Subject: **Bid No. 8721-M6 – Sewer Rehabilitation - Various Streets (S26-2) / DPW**

ADDENDUM NO. 2

VARIOUS STREETS 2026
SEWER REHABILITATION
PROJECT

Drawing Title:
**BUILDING
CONNECTION DETAIL**

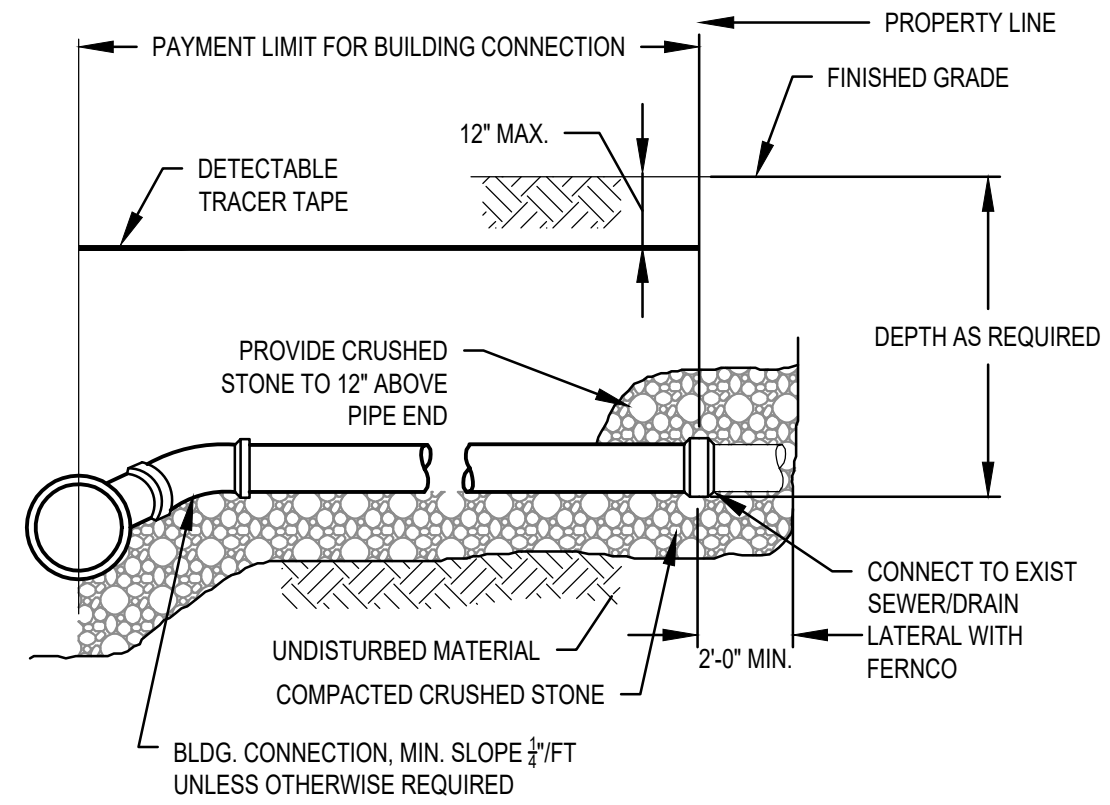
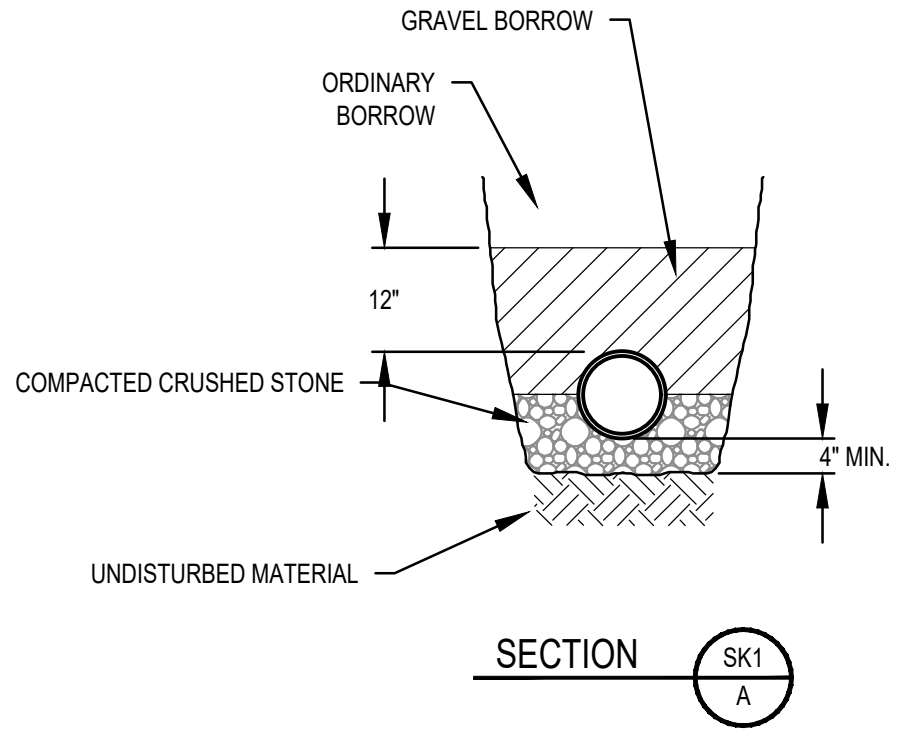
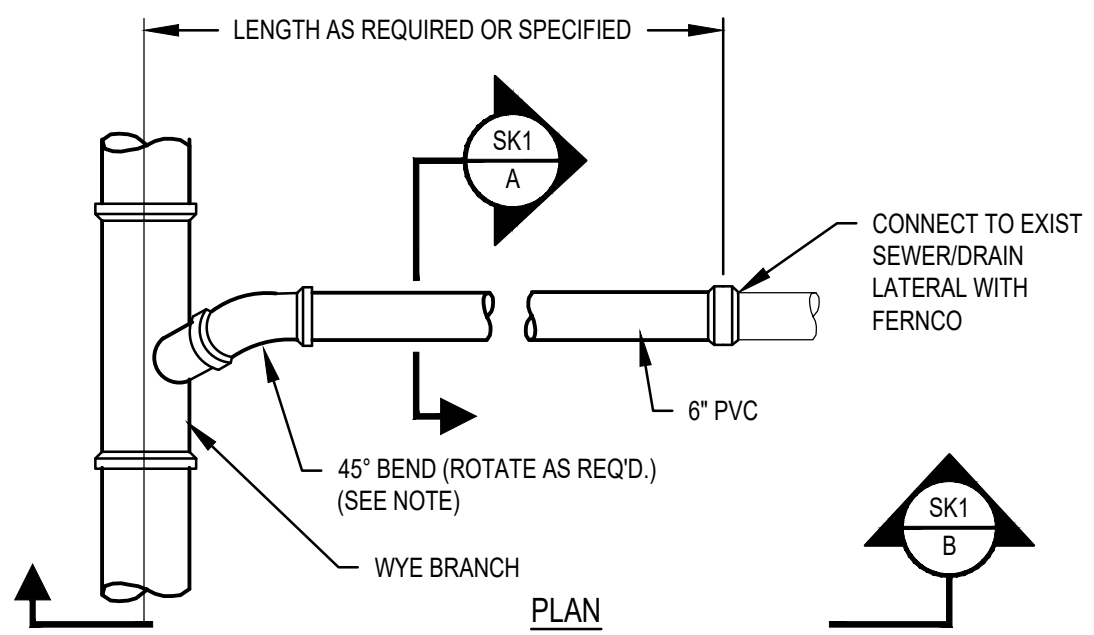
- A2. **Yes. It is anticipated that the 12-inch pipe on Queen Street may require open cut repairs prior to installation of CIPP.**
- Q3. Can the owner clarify how the bid item “connections” will be paid and what it covers? Bid item 224.

- A3. **Measurement and Payment of bid item 224 is provided in the City’s Department of Public Works Standard Construction Specifications and Details. See attachment SK1 for additional building connection details.**
